SUNDRY NOTICES AND REPORTS ON WELLS

MCA Unit No. 356

PROPOSED WELLBORE DIAGRAM MCA 356

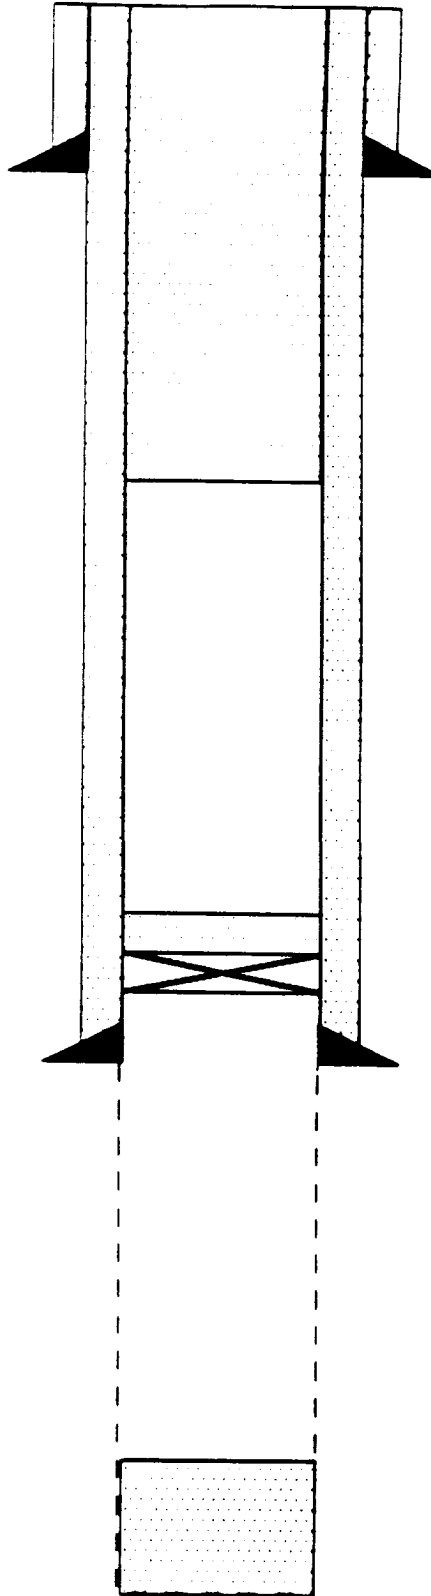
Approval to P&A this well was granted by the BLM on 1/19/93. As per verbal approval by Shannon Shaw on 2/23/93, it is proposed to make the following change in the approved procedure:

1. Instead of drilling out the CIBP @ 3960' and filling the open hole section below it with cement, just tag the CIBP and the cement plug on top of it and leave them in the hole.
2. Then proceed with the 300 sx cement plug from 2400' to surface.
3. The attached wellbore diagram illustrates this revised procedure.

SURFACE/SALT PLUG
300 SX FROM 2400-SURFACE

CIBP @ 3980' W/ 10 SX CMT
